**RE: Ripogenus Project (FERC P-2572-141) and Penobscot Mills Project (P-2458-273)
Caribou and Chesuncook Lake Camp Association (CCLCA) Response to
GLHA June 2, 2026 Comment Letter**

The Caribou and Chesuncook Lake Camp Associations (CCLCA) hereby files with the Federal Energy Regulatory Commission (FERC) the following responses to comments provided by Great Lakes Hydro America, LLC on June 2, 2026 for the Ripogenus Hydroelectric Project (P-2572) and the Penobscot Mills Hydroelectric Project (P-2458), collectively the “Projects”.

Ripogenus Elevation 1982 (average hydrologic year)

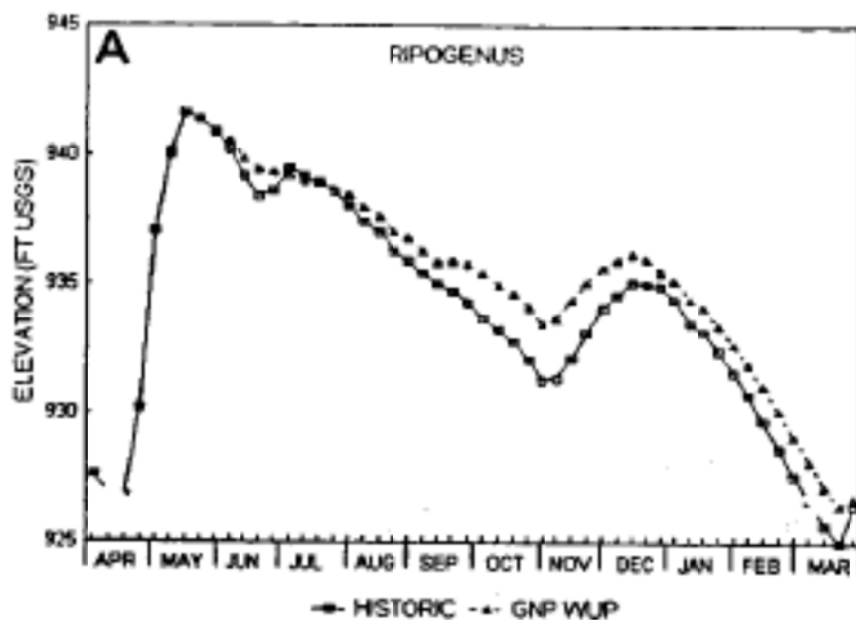
The first graph of historical elevations is from GNP’s 1996 Water Use Model. The graph is a portion of Figure D-7 and shows weekly average RIP Impoundment elevations for the year 1982, an “average” hydrologic year. The graph shows both historic and simulated elevations. Maximum impoundment elevation was 941.6 msl in late May; the elevation in mid-September was approximately 937 msl (4.6 feet drawdown). Historic and simulated elevations were very close over the growing/recreation season. The winter drawdown level was approximately elevation 925 msl in mid-March. This historical graph closely resembles the CCLCA proposal. This graph represents operations before recreation flow requirements.

Ripogenus Elevation 2009 (wet-average year)

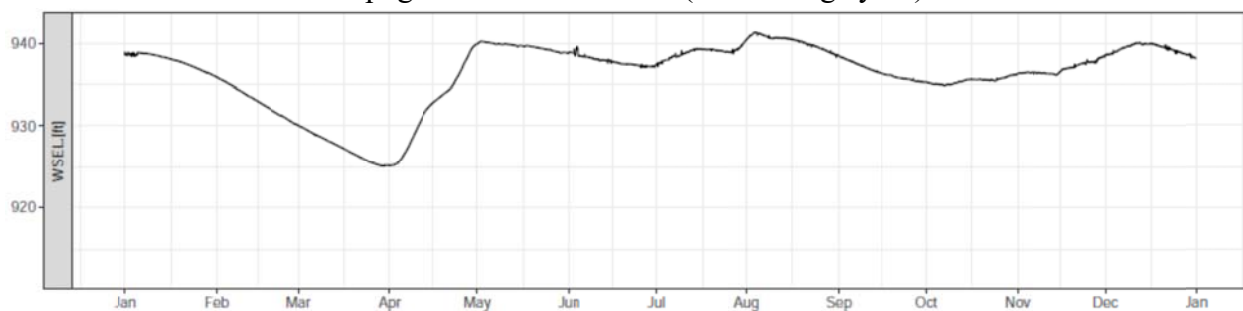
The two graphs below are from the 2024 ISR report and illustrate historical observed Ripogenus elevations for the years **2009 (wet-average year)** and **2014 (average year)**. These two graphs represent GLHA operations with recreation flows 8.5 hours daily (the proposed license reduces recreation flows to 6.5 hours daily).

In 2009, elevation 940.1 was reached in early May and RIP was maintained above elevation 935.0 until early October. The winter drawdown reached elevation 925.0 in late March.

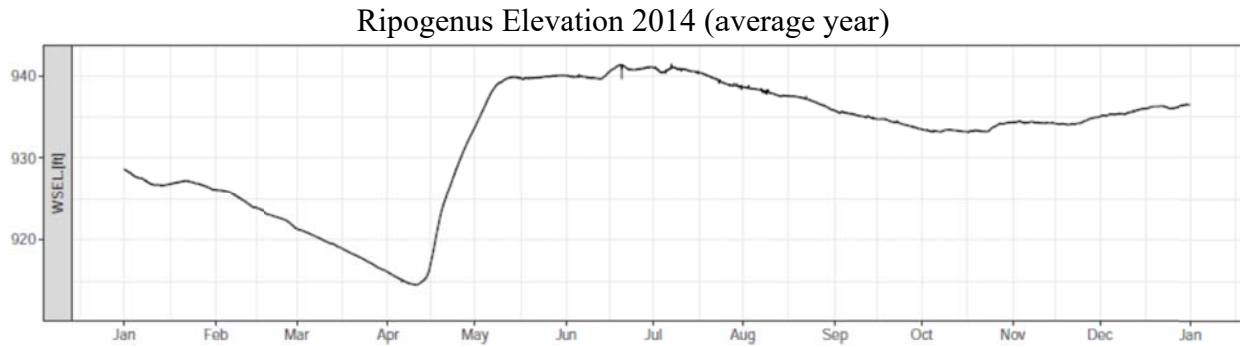
In 2014, as shown below, elevation 940.1 was reached in late May and RIP was maintained above elevation 935.0 until mid-September. The winter drawdown reached elevation 925.0 in mid-February and lowered to approximately elevation 915.0 in mid-April. The 2009 and 2014 historical graphs support the CCLCA proposal.
